Nature of Work: DUPLEX T/O REROOF W PIONEER TILE

SUBJECT: Roof inspection at 6781 Breakwater Way & 3770 Riptide Way, Sacramento, CA 95831

ROOF PLAN FOR:
0781 BREAKWATER MAY 4 0770 R/P/P/D/E W/AR
SACRAMENTO, CA 95831

BRACING OF MICROLAM PURLIN IN THE FIELD

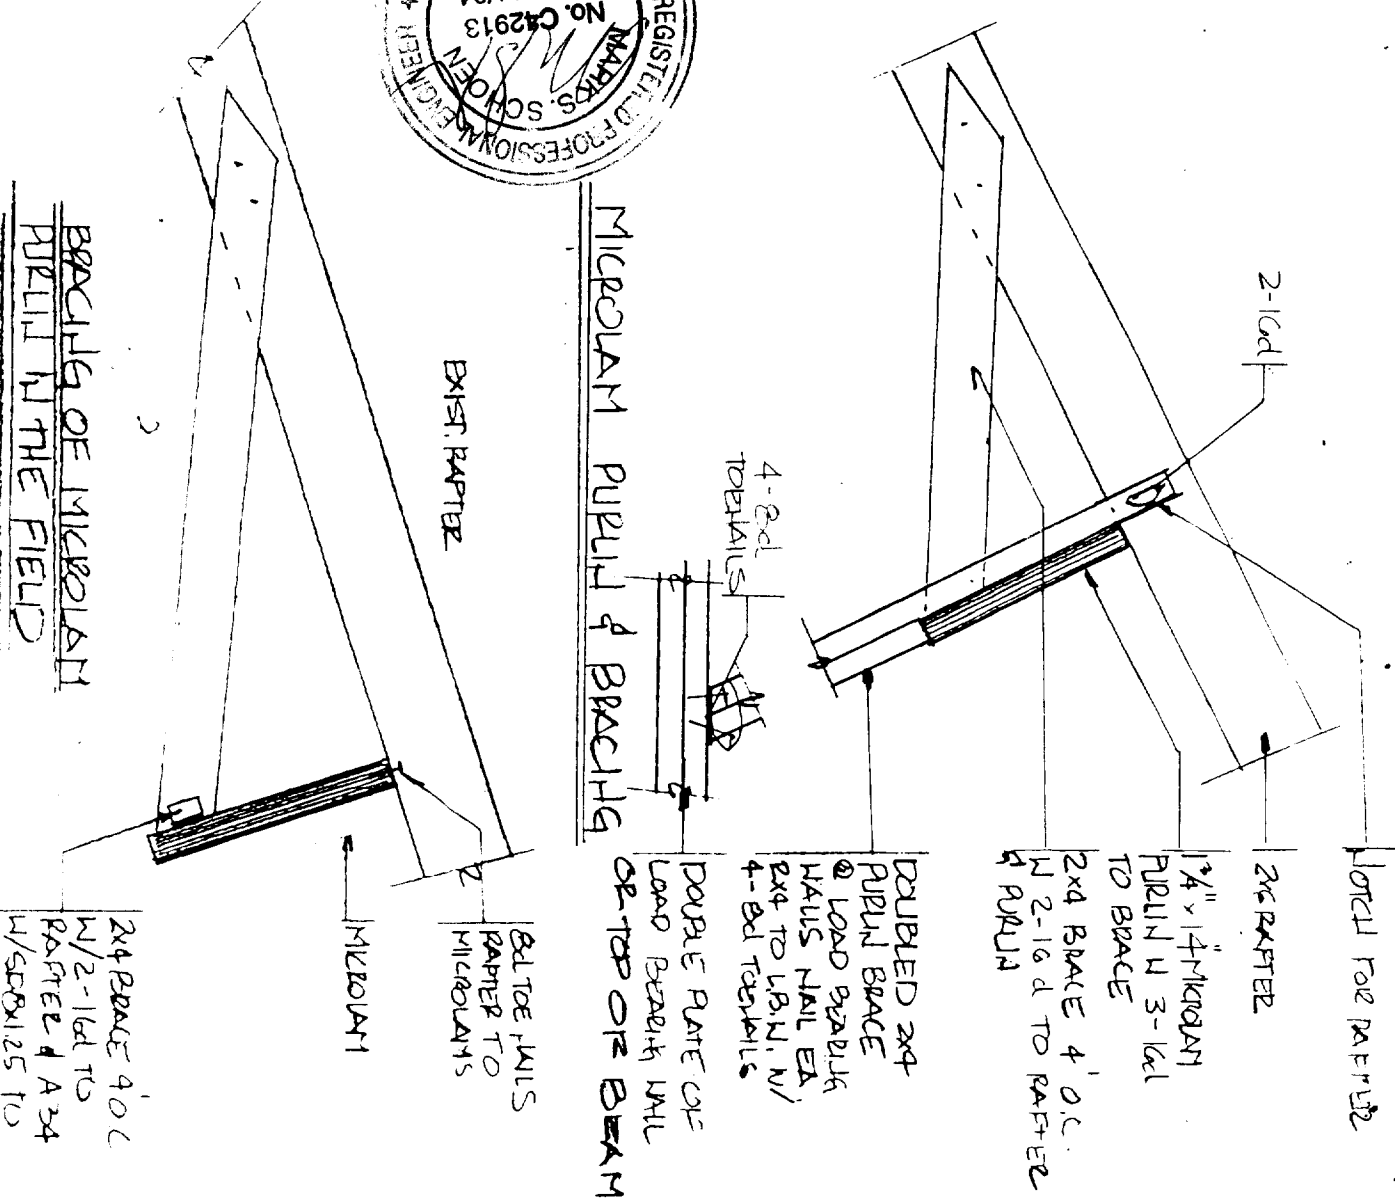
* In the garage the rafters in the front slope facing the street are overspan. In this area install a 1-3/4"x14" Microlam purlin approx. 8'-9" in from the exterior wall plate(see sketch for detail and plan for location).

GARAGE ROOF
SUPPORT BEAM

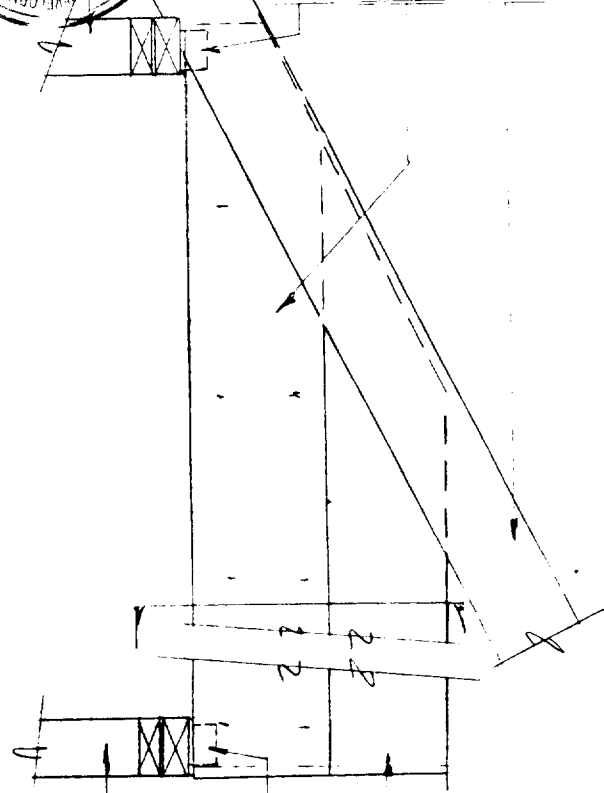
* In the garage the ends of the small section of ridge in the middle of the garage as well as the upper ends of the hip and valley rafters need to be supported. To do this install a beam made up of 2(two) 1-3/4"x11-7/8" Microlams between the wall facing Riptide Way and the fire wall between the house and garage. The ends of the ridge as well as the hip and valley rafters should then be braced off of this beam(see sketch for details and plan for location).
